# **New Jersey Department of Transportation**

## **FACILITIES ADA SITE INSPECTIONS**

### **(Updates and Recommendations)**

## **2023**

## Trenton Headquarters

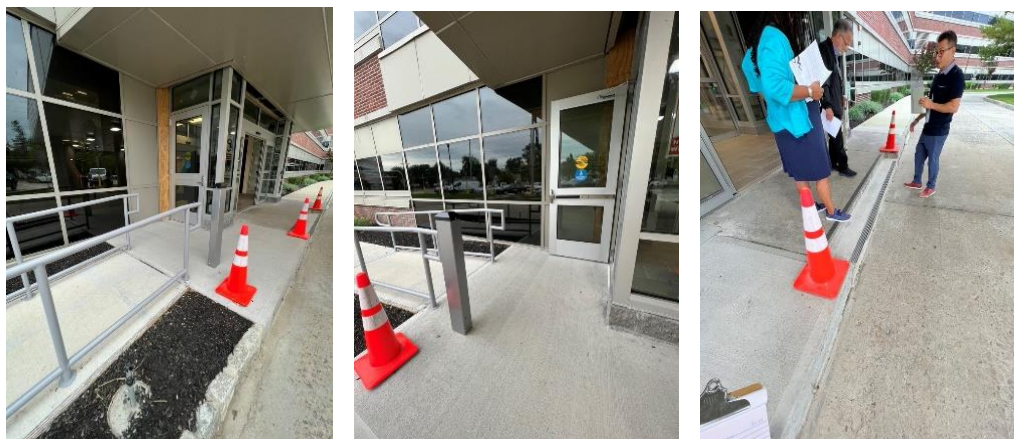
- 1) At the time of the site inspection, the entrance was under construction. After construction, there will be two yellow bollards placed on each side of the entrance, totaling four for ADA accessibility identification.

- 2) Recommended restriping accessible parking space in front of MOB.

- 3) Recommended installing a Detectable Warning Surface (DWS) on the sidewalk from Lot B toward MOB.

- 4) Deteriorated concrete sidewalk poses a tripping hazard and will be repaired.

- 5) Security sign-in station: It is recommended that a table be permanently provided for ADA accessibility between 27in. - 34in. in height.

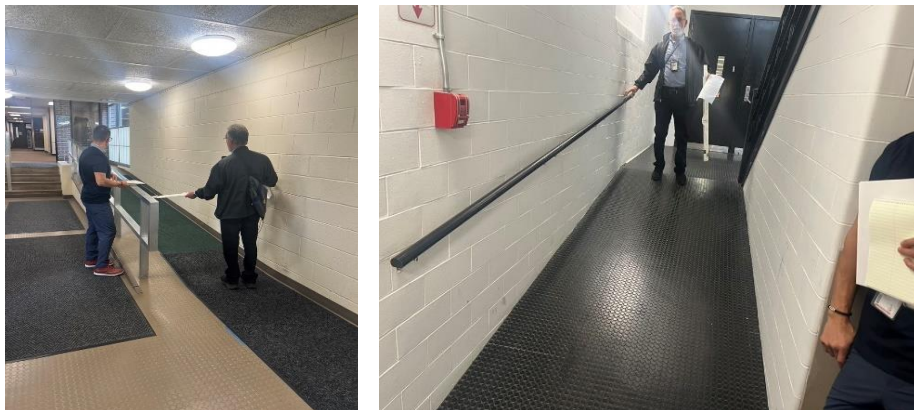
- 2) It is recommended that a handrail be installed along ADA ramp at entrance/exit near security station.  
(See picture on the left) ↓

- 4) It is recommended that an additional handrail be installed along ADA ramp between MOB and F&A. (Handrail should be on both sides) (See picture on the right) ↑

### **E&O Building:**

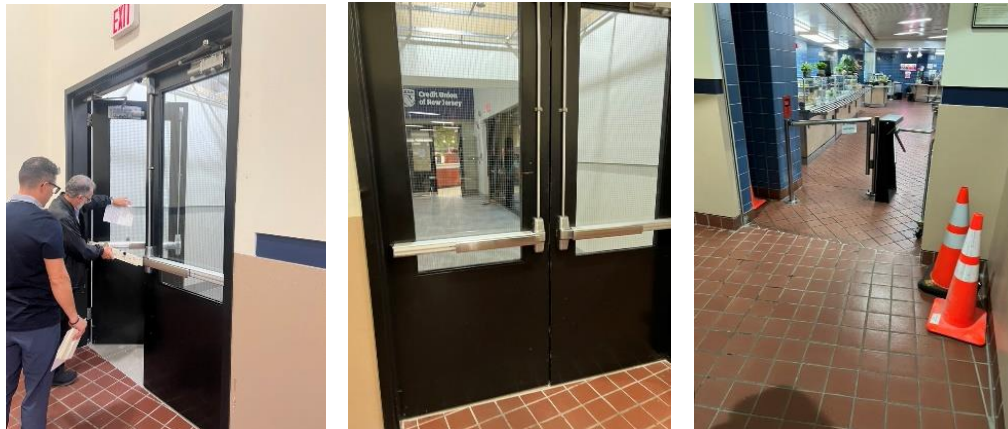
- 1) One automatic ADA accessible push-button door will be installed at the main entrance to the cafeteria.
- 2) The cafeteria entrance door (near Credit Union) will be replaced and calibrated to comply with opening and closing forces for ADA compliance. One automatic door ADA accessible push-button door will be installed.

**Update: On October 30, 2023, automatic ADA accessible push-buttons were installed at cafeteria doors.**
